Planning Application No. A/YL-SK/430

主旨: Planning Application No. A/YL-SK/430 - Submission of Further Information

Proposed Temporary Public Vehicle Park (excluding container vehicle) and Associated Filling of Land for a Period of 3 Years Planning Application No. A/YL-SK/430

Appendix I - Response-to-Comments Table

drawing title. LAYOUT PLAN

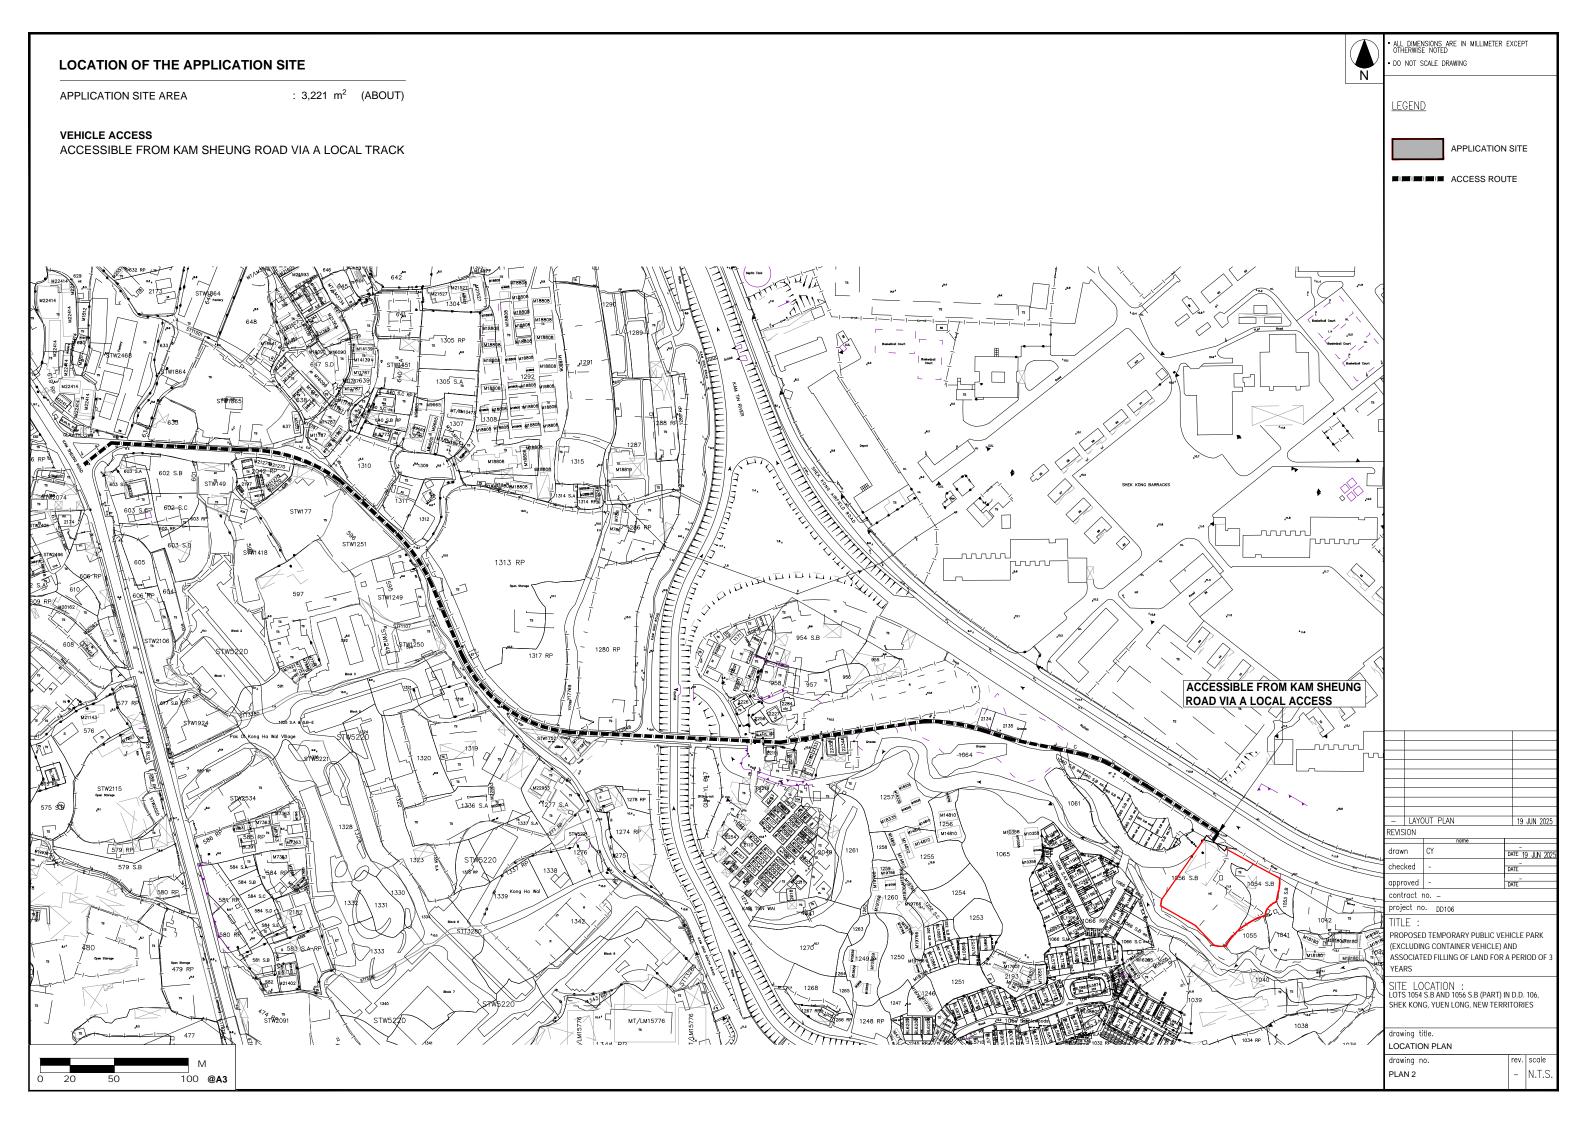
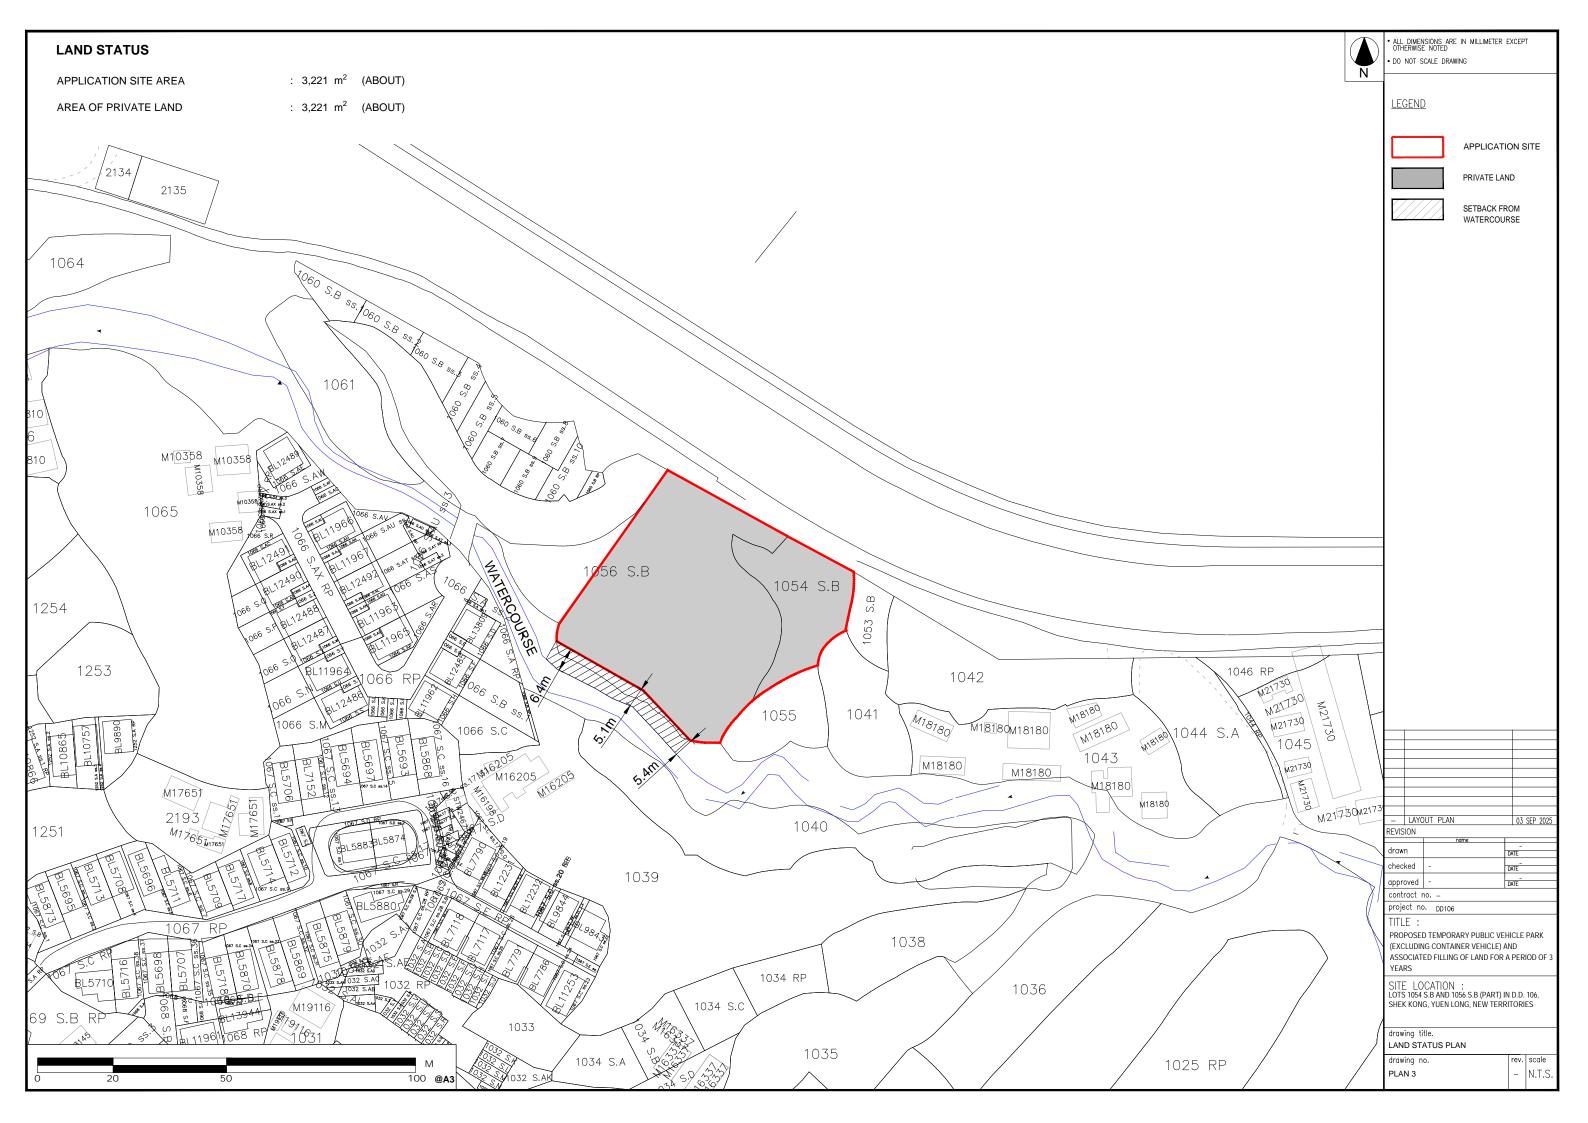
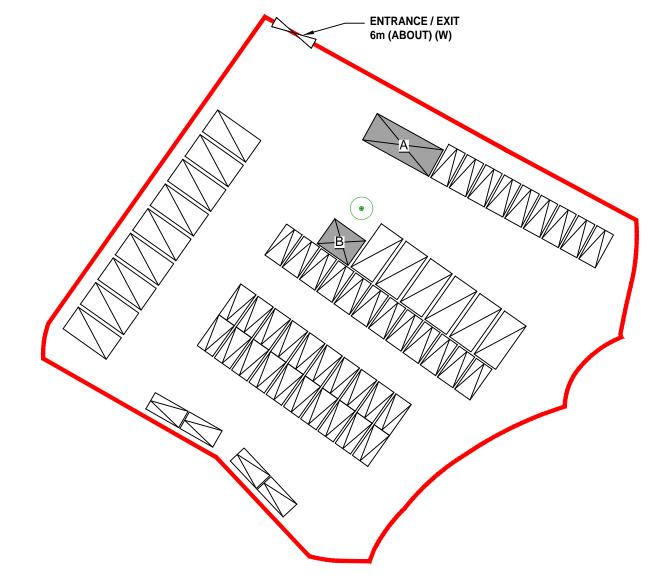
(a) There are existing streamcourse/channel on government land in the adjacent of application site. Drainage reserve is required for operation and maintenance of the streamcourse/channel. Therefore, I would recommend the application site to exclude the Government Land from the captioned S.16 application.	The application boundary has been revised to exclude the Government Land and to maintain about 5m setback from the watercourse. Please refer to Appendix III for the revised plans.

(b) In addition, the applicant shall be required to place all proposed works 3m away from the top of the bank of the impacts, both during and after construction.	The revised site boundary has taken the 3m distance from the top of the back of the impacts into consideration. The applicant will place all proposed works during and after construction beyond the said distance.

In view of the comments from the Agriculture, Fisheries and Conservation Department and the Drainage Services Department, the application site boundary has been revised to exclude the Government Land portion in the south to maintain a minimum setback of 5m from the watercourse. As a result, the updated site area should be about 3,221m², which is reduced by 328m² (-9.2%). Please refer to **Appendices II and III** for the updated development parameters.
